Historic Preservation Services for 1924 Bungalow: Guest House
414 Greenbriar Drive, Lake Park, FL 33405

REG Project # 22044

Project Description:

- A. Guest House Option 1: Existing two-over-two single hung window, west elevation, all proposed windows shall match historic windows.

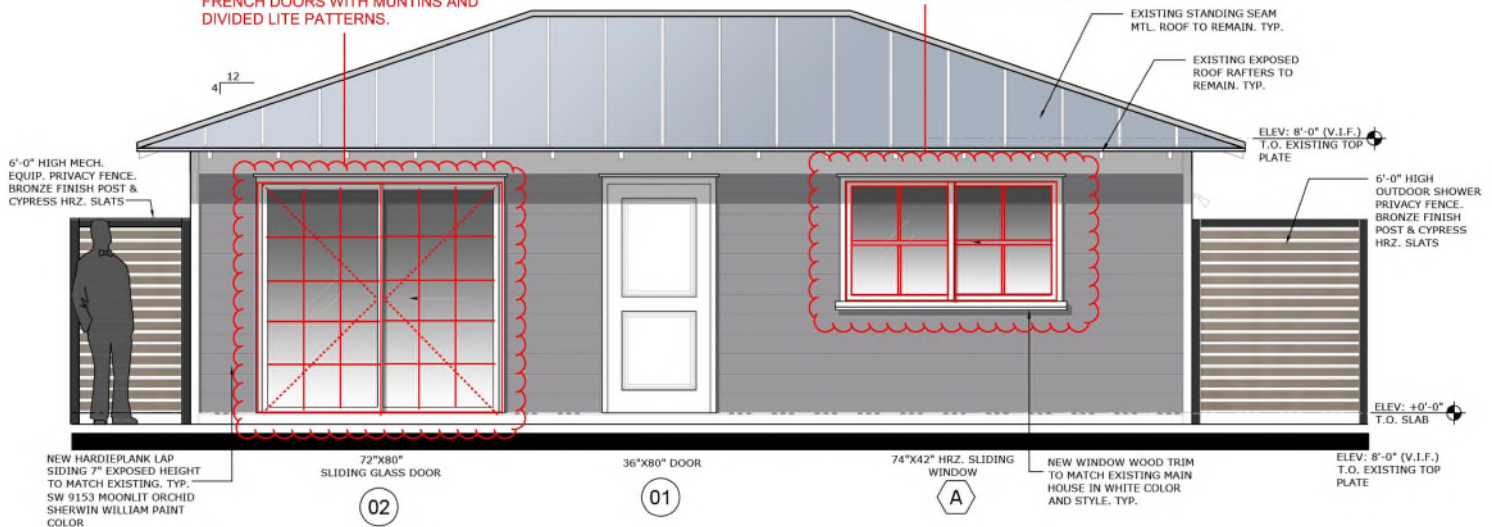
- B. Historic Main House Option 2, Existing six-over-one single hung window, north elevation, Guest House proposed windows shall match historic windows.

PROPOSED NORTH ELEVATION

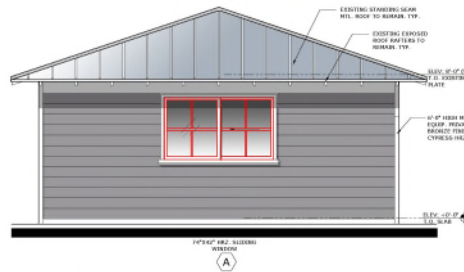
- C. Guest House: Existing wood doors, shall be replaced with outward swinging, French doors with muntin divided lite pattern, North Elevation.

GUEST HOUSE DOORS SHALL MATCH WITH SIMILAR HISTORIC FEATURES SUCH AS OUTWARD SWINGING FRENCH DOORS WITH MUNTINS AND DIVIDED LITE PATTERNS.

ALL WINDOWS SHALL MATCH HISTORIC FEATURES AND FUNCTIONALITY OF GUEST HOUSE OR MAIN HOUSE WINDOWS, SUCH AS, TWO-OVER-TWO SINGLE HUNG OR SIX-OVER-ONE SINGLE HUNG. THEREFORE, WINDOWS SHALL HAVE MUNTINS AND DIVIDED LITE PATTERN, MATCHING HISTORIC WINDOW CONFIGURATION.

F. Guest House: Overlay of Historic Preservation comments on Proposed North, East, West, and South Elevation, French Doors and Single Hung Windows to match with similar historic features of Main House and Existing Guest House windows (muntin configuration).

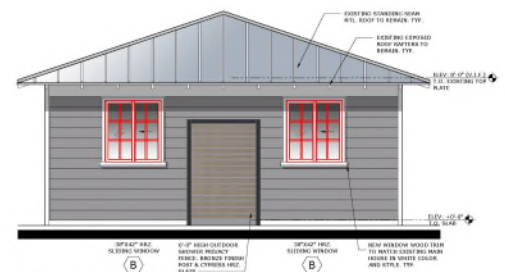
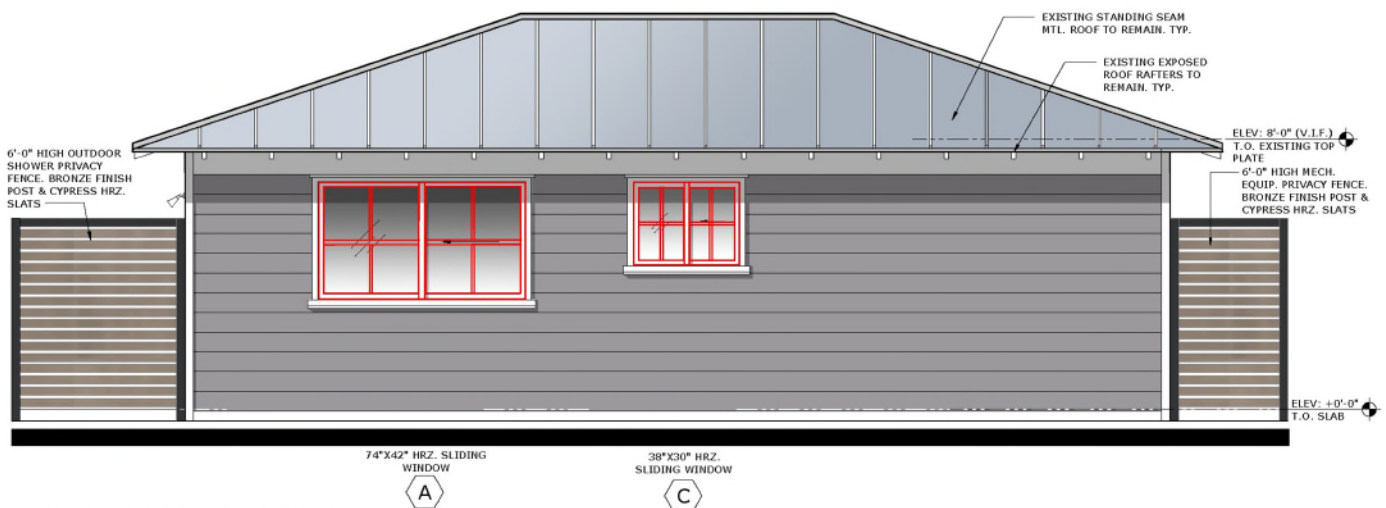
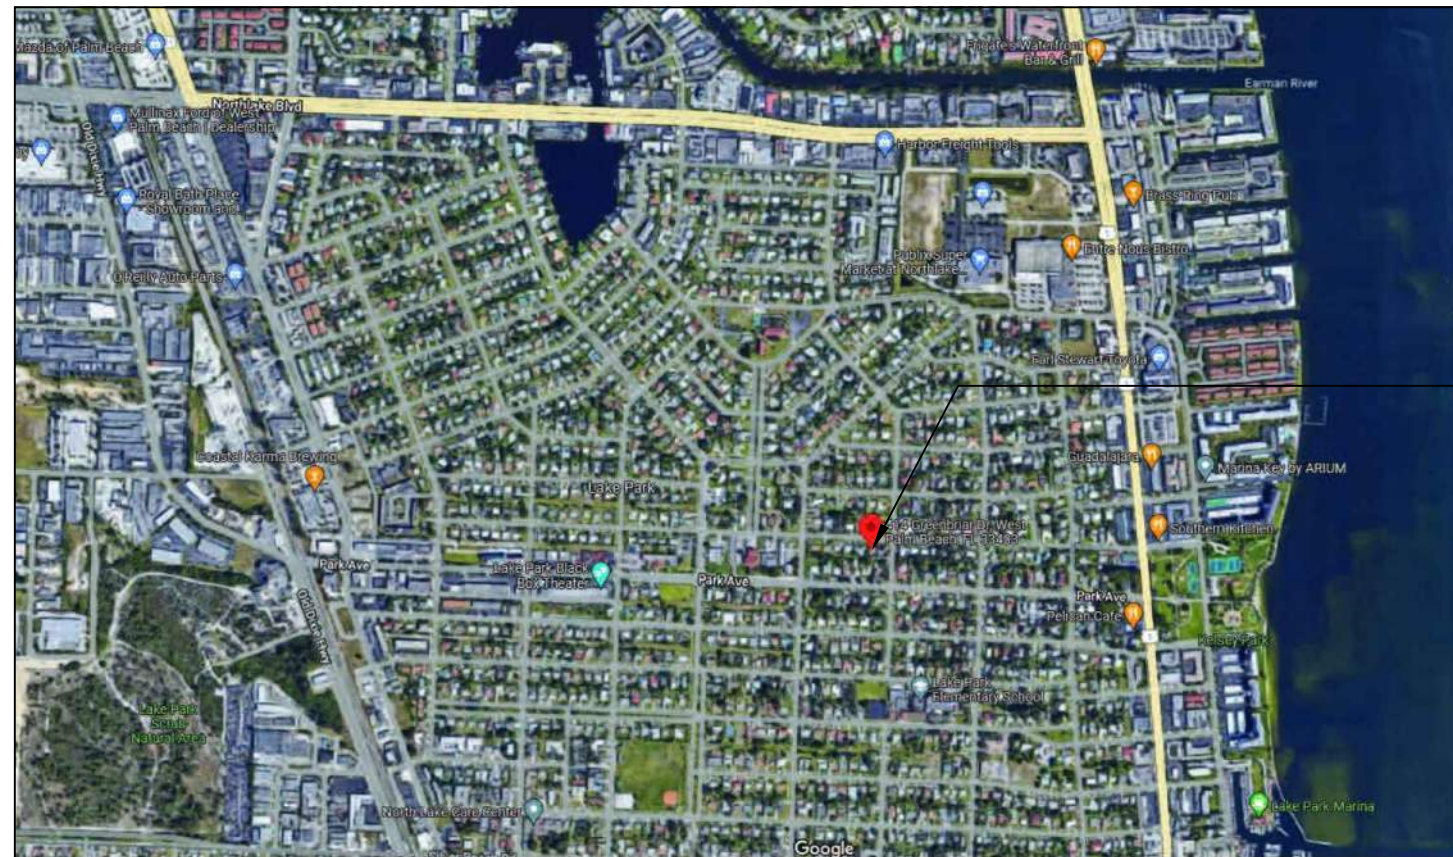
- D. Guest House, Existing exposed rafters and standing seam metal roof shall remain, South Elevation, as noted in attached drawings, see sheets A-1, A-1.1, and A-1.2.
- E. Exhibit Attached: Design drawings from Applicant.
